Work Order ID 84885

Item Name: Skidtube LH

DART SERVICE INSTRUCTION

TO AMEND INSTALLATION INSTRUCTIONS IIN-D209-669 REV. B

INSTALL TOW RING ASSEMBLY AS SHOWN BELOW (REFER TO SECTION F-F OF IIN-D209-669 REV. B.

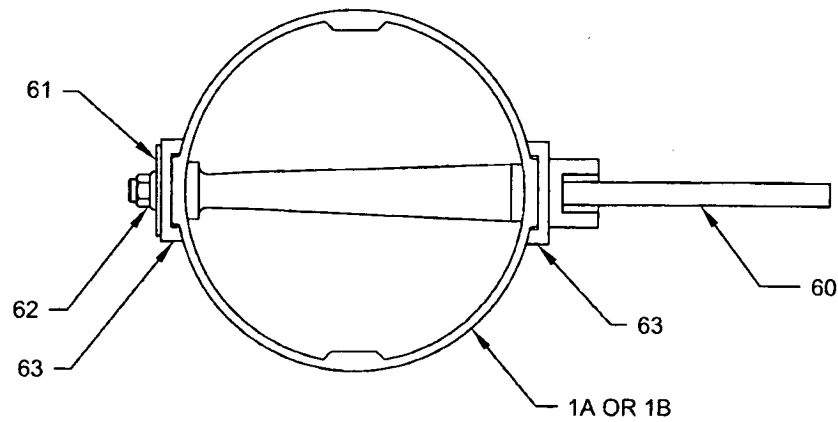
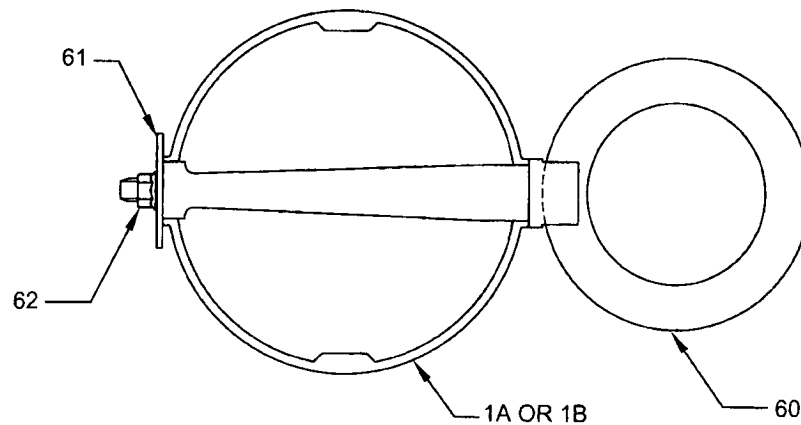
IS:

WAS:

- a) REPLACE THE D2968-041 TOW RING WITH THE D3407-041 TOW RING ASSEMBLY.
- b) REPLACE THE D2736-1 AND D2736-3 GHW LUGS WITH THE D3405-041 AND D3405-043 LUG ASSEMBLIES.
- c) AMEND THE PARTS LIST IN SECTION 5.0 OF INSTALLATION INSTRUCTIONS IIN-D209-669 REV. B AS SHOWN ON PAGE 2 OF THIS DSI.
